**SOIL, GEOLOGY, AND GEOLOGIC HAZARD STUDY  
STERLING RANCH FILING NO. 5  
PARCEL 16  
EL PASO COUNTY, COLORADO**

November 22, 2022  
Revised December 1, 2023

**PERIMETER DRAIN DETAIL**  
 STERLING RANCH FILING NO. 5  
 PARCEL 16  
 COLORADO SPRINGS, CO  
 FOR: CLASSIC SRJ

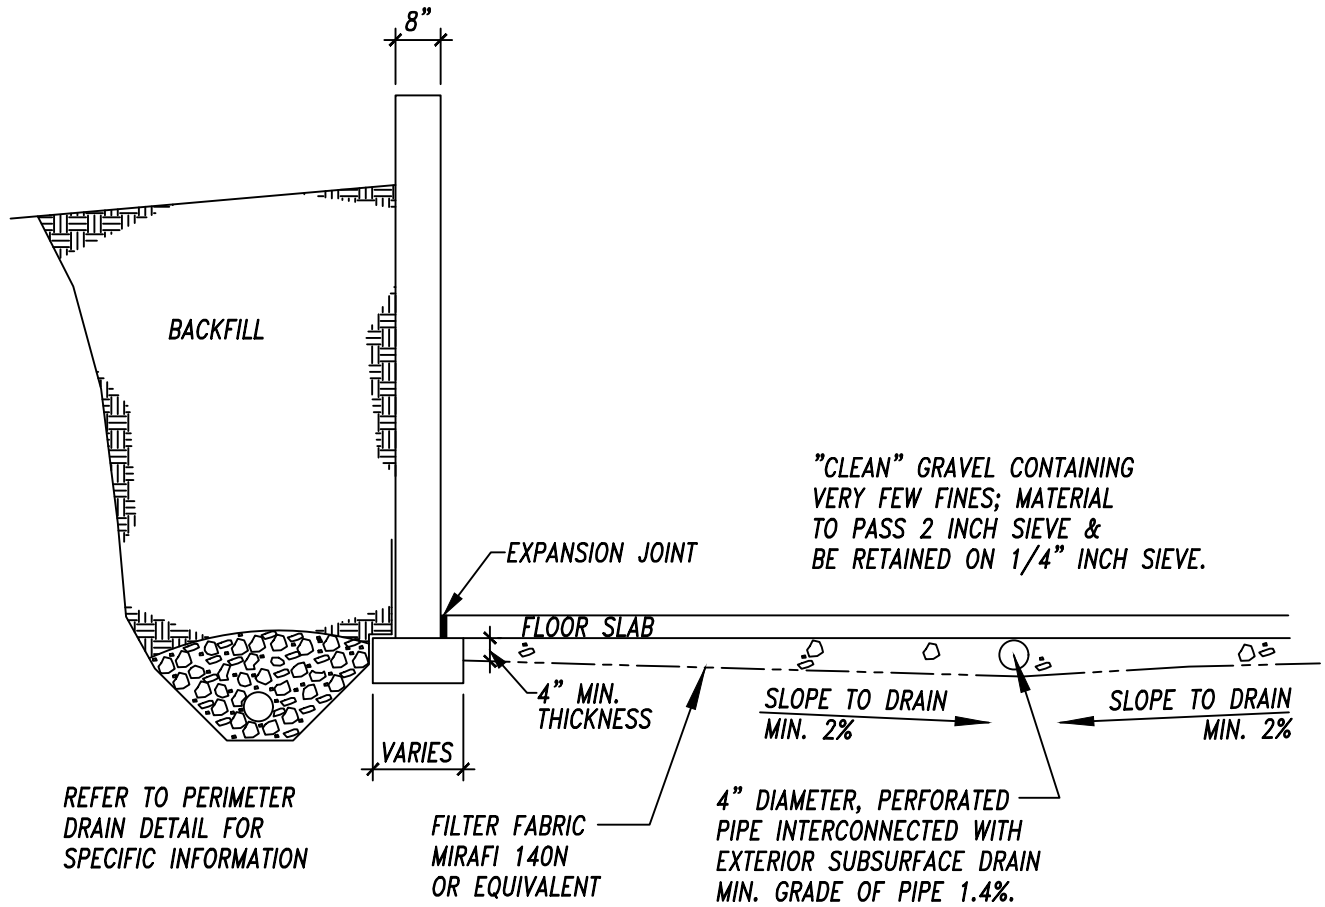
See my comment on PDF pg 11 above about out-falling groundwater to land. And consider need to revise this detail accordingly.
